Addendum D1

re: **Fort Wayne Community Schools**
Holland and Northcrest Elementary School Renovation
111031.00

issue date: **October 9, 2025**

Mechanical Plans

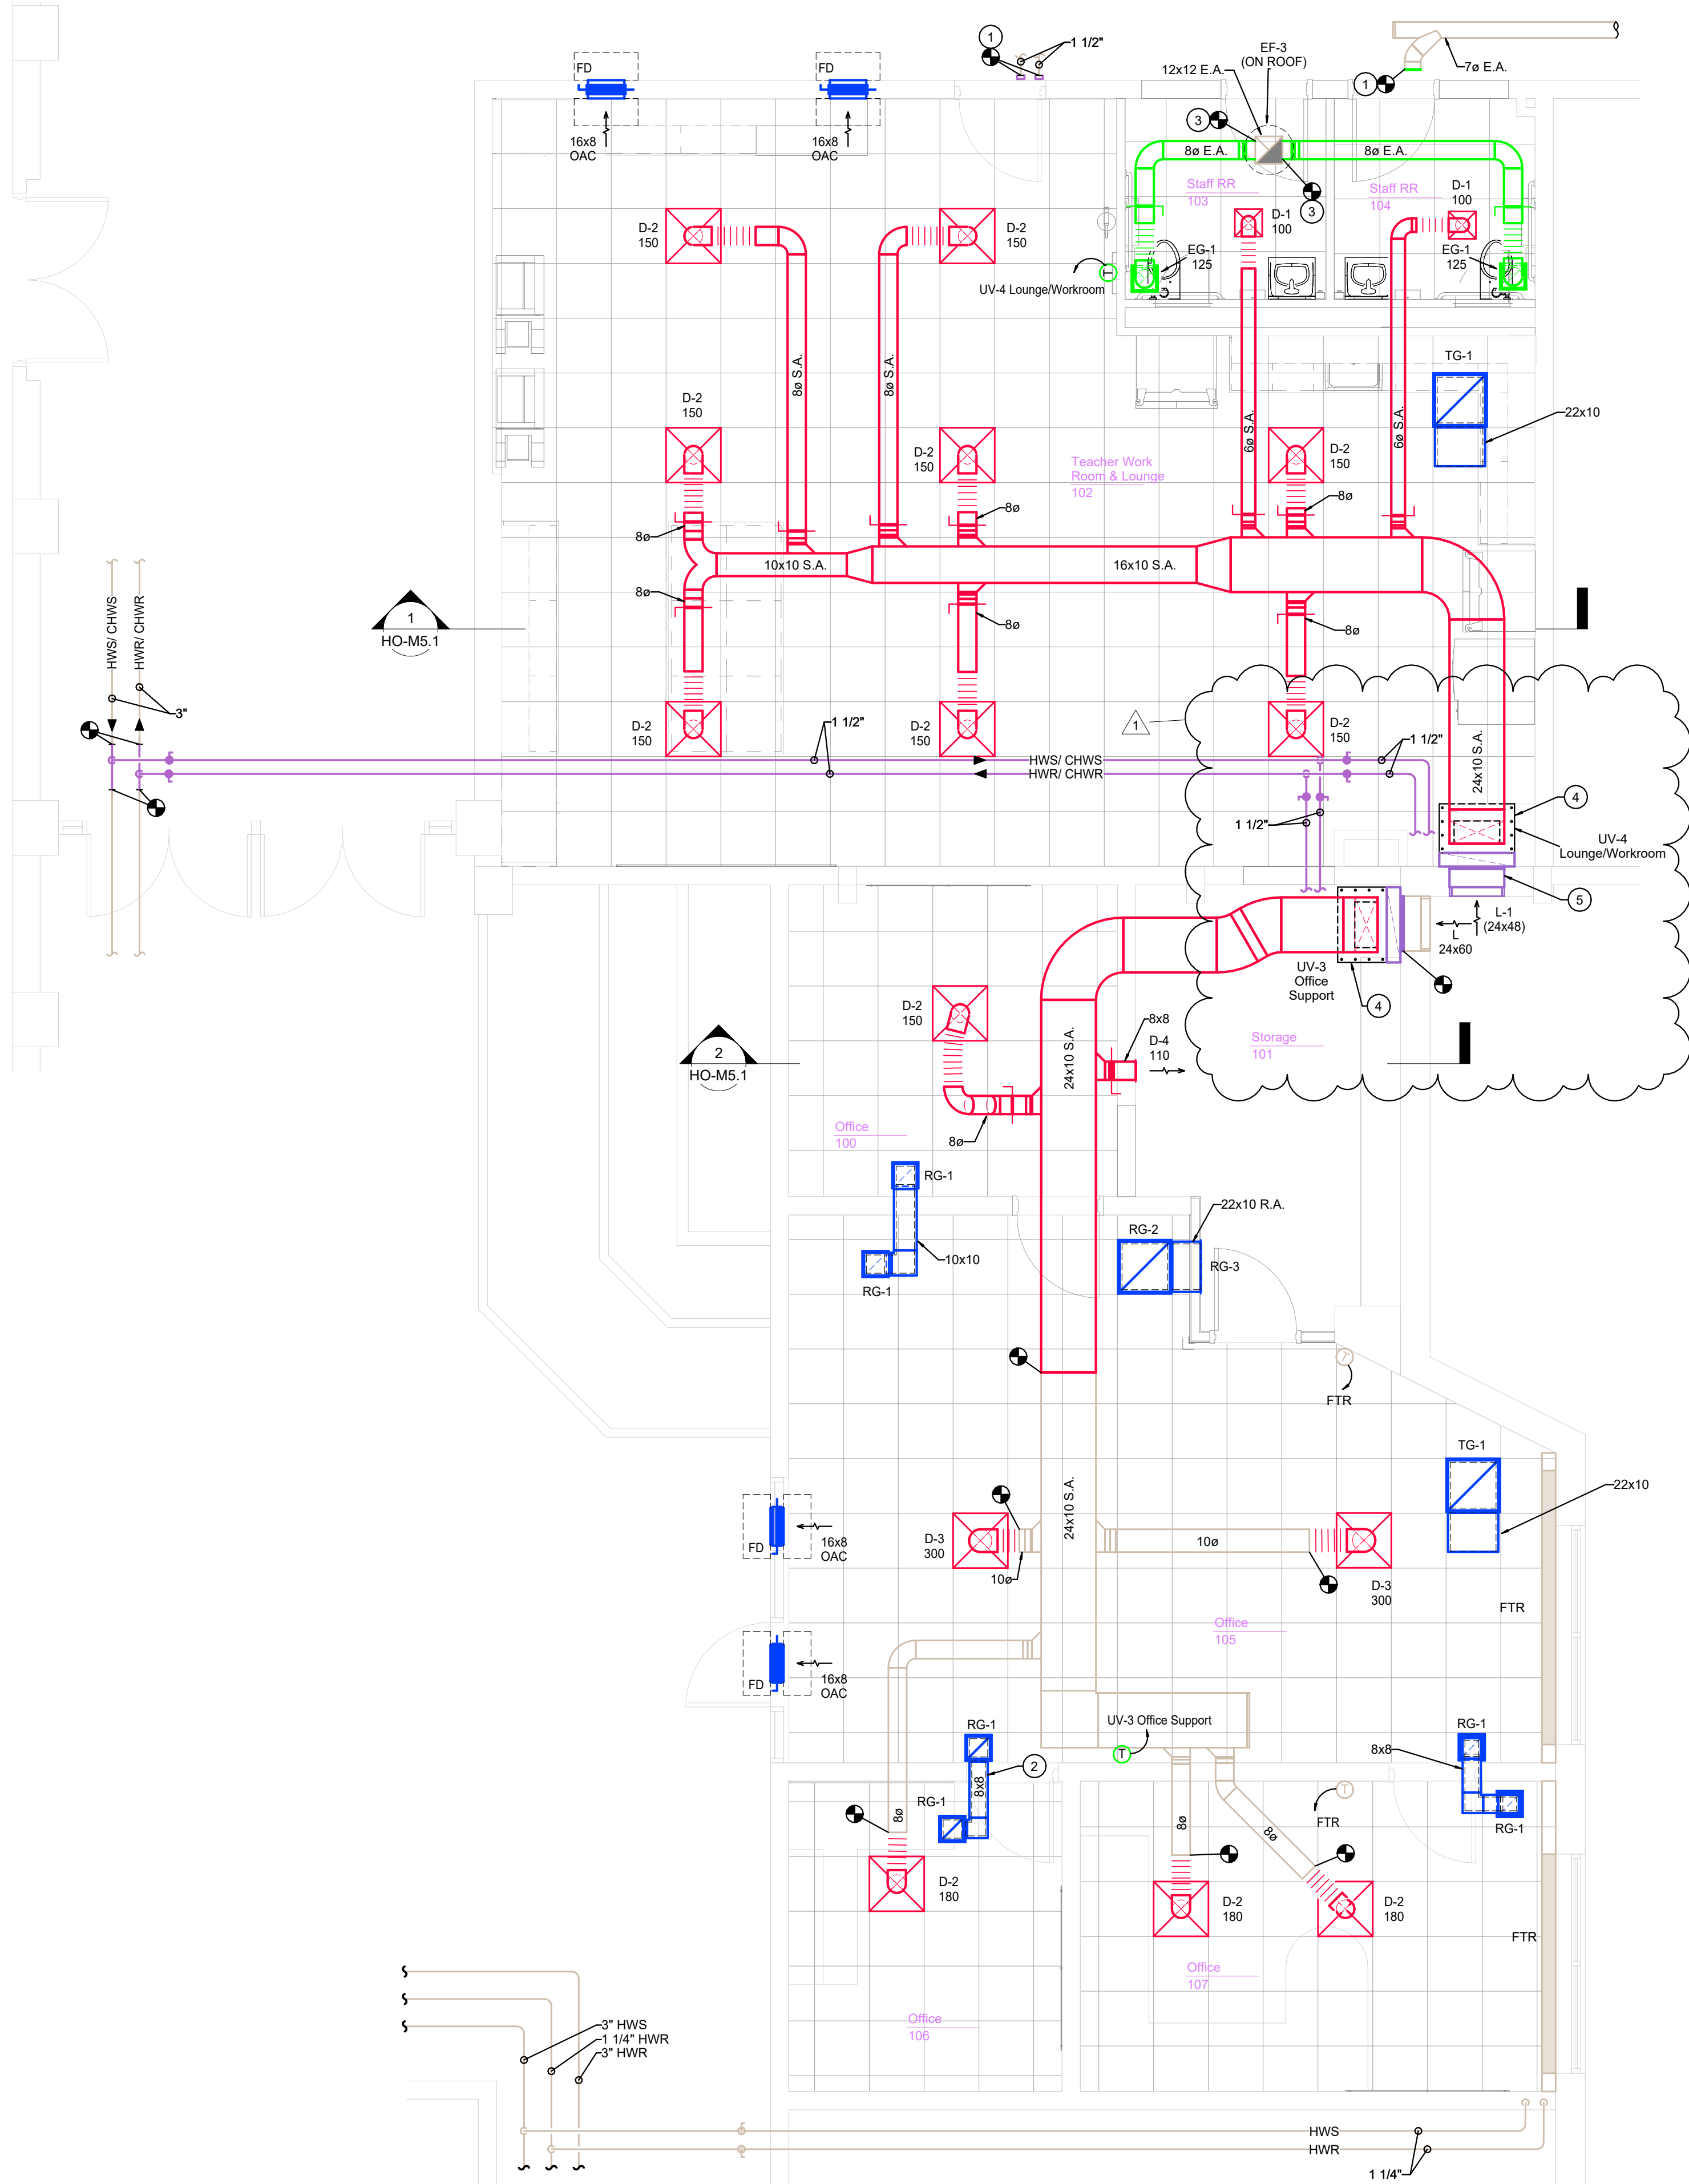
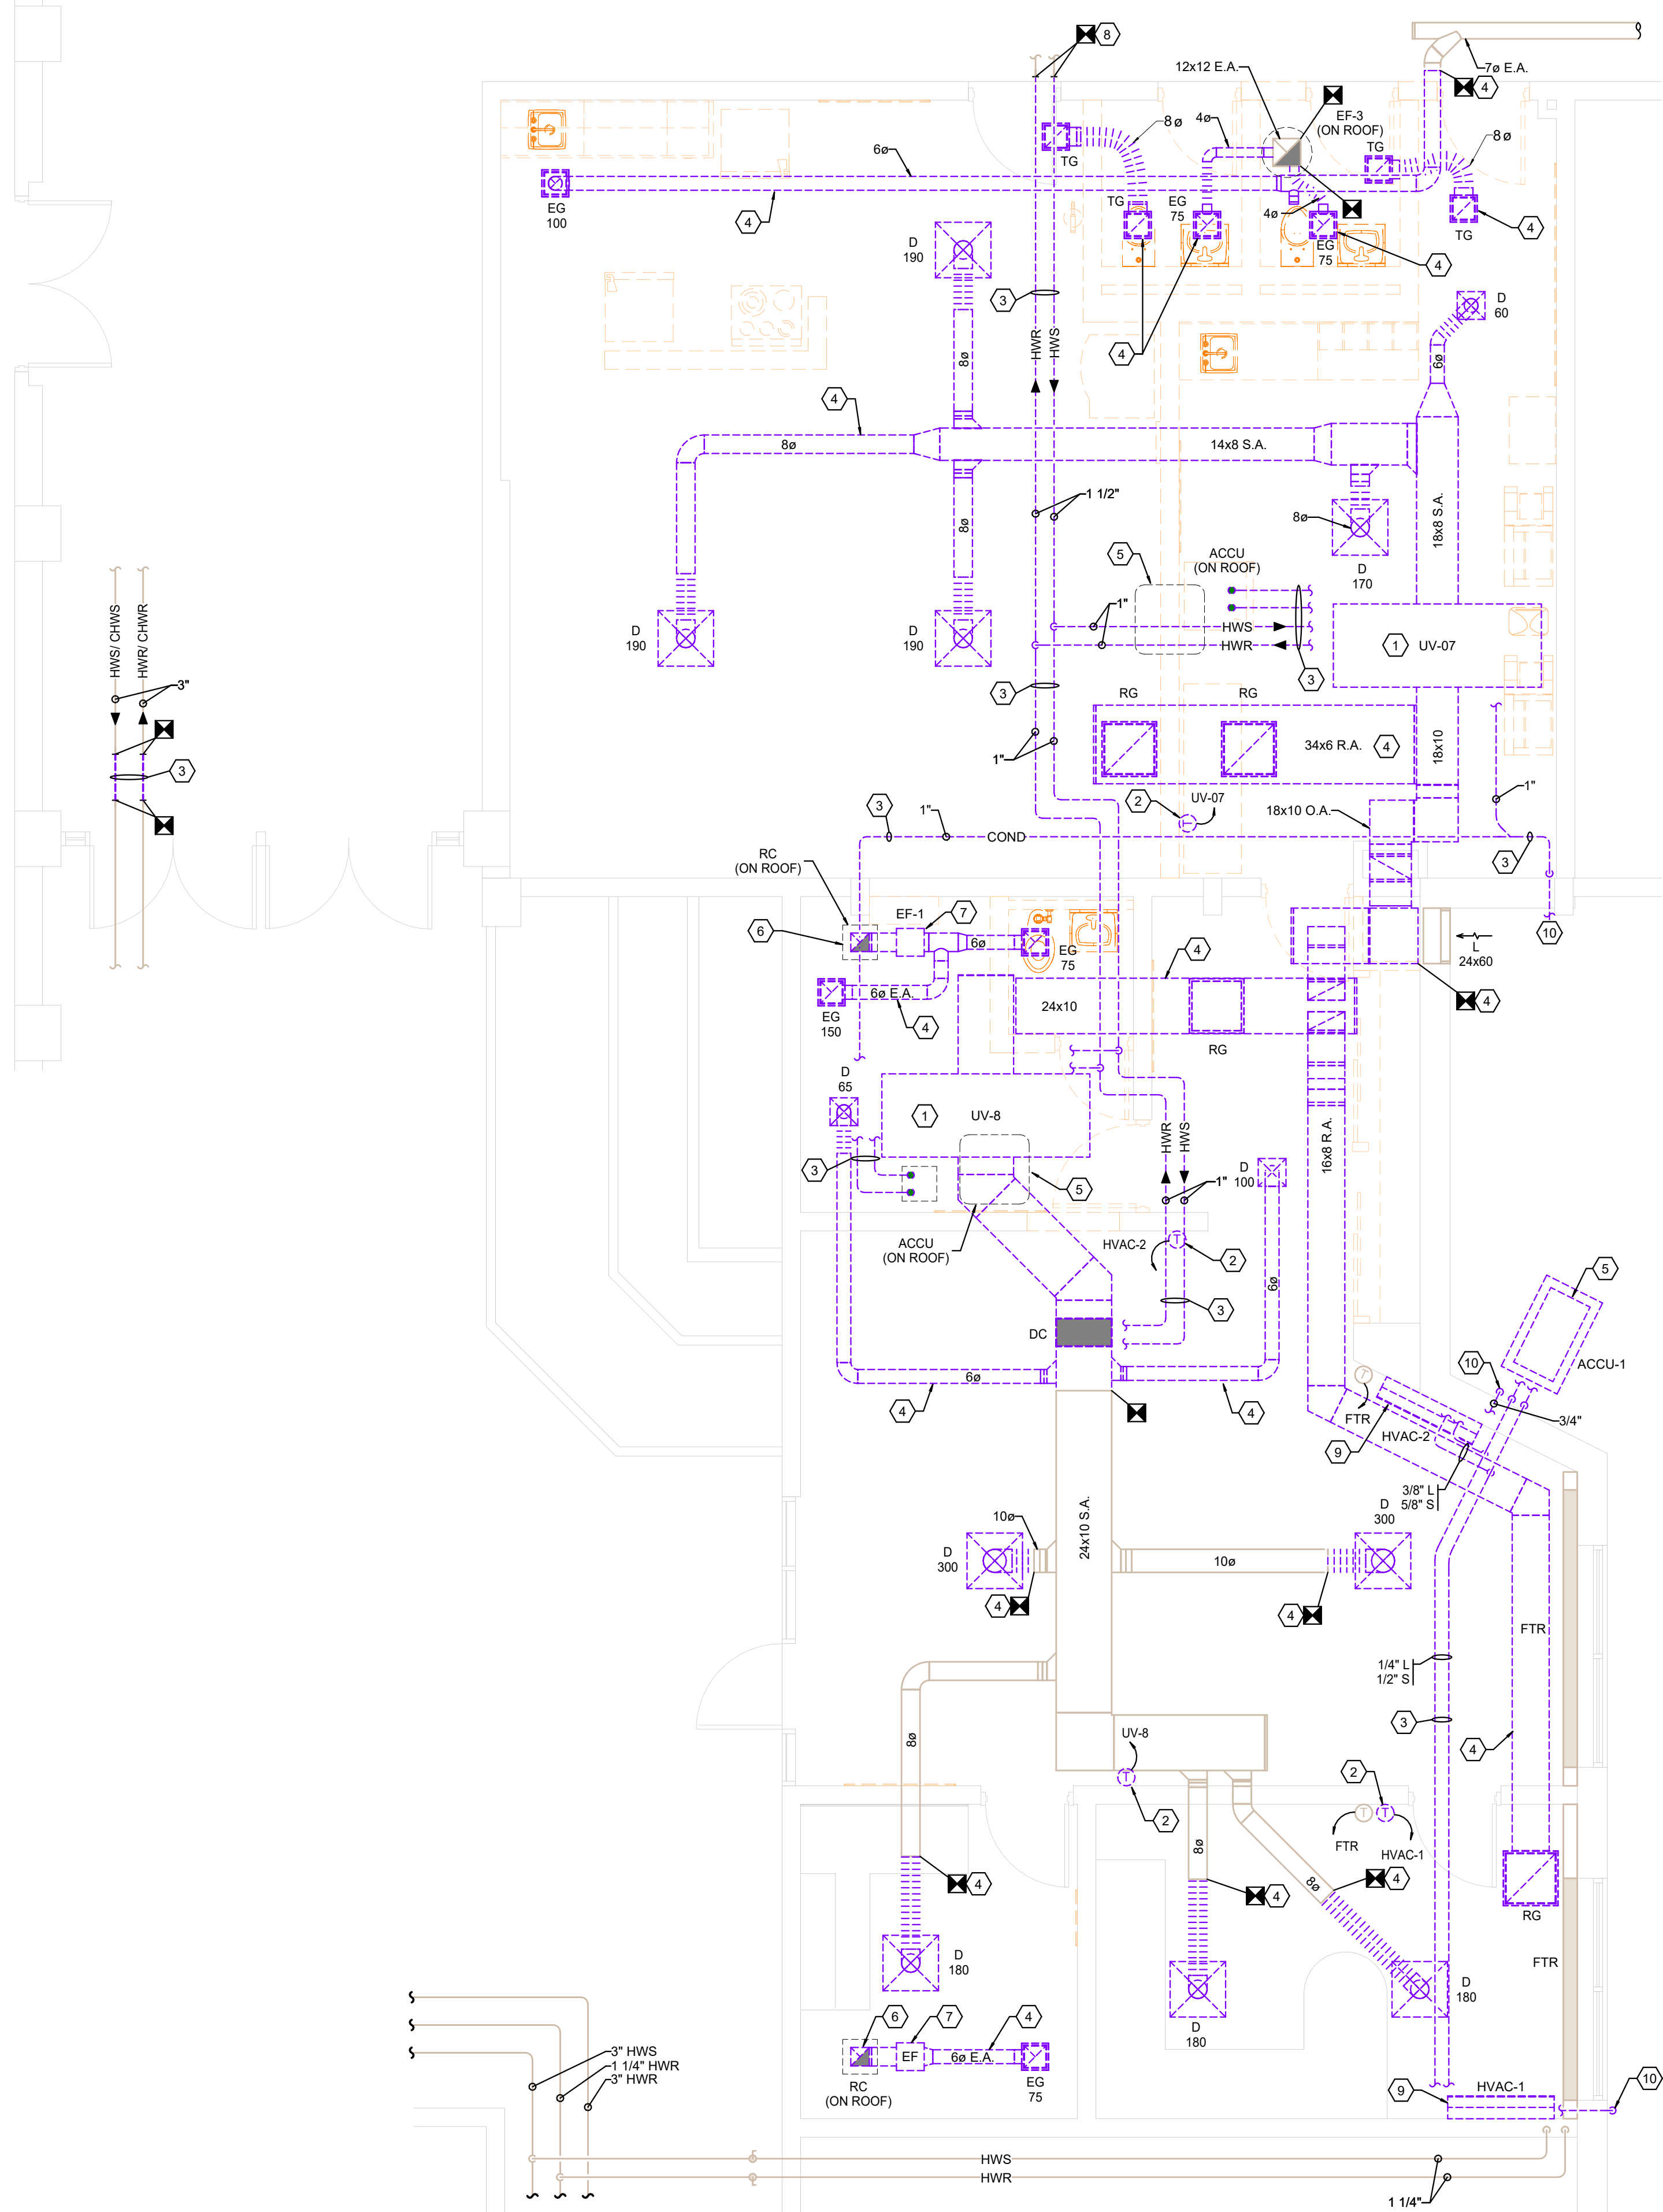
Item #3: Drawing Sheet HO-M2.1, "Mechanical Plans".

- A. Revised new mechanical equipment naming conventions. Refer to supplemental sheet HO-M2.1 for additional information.
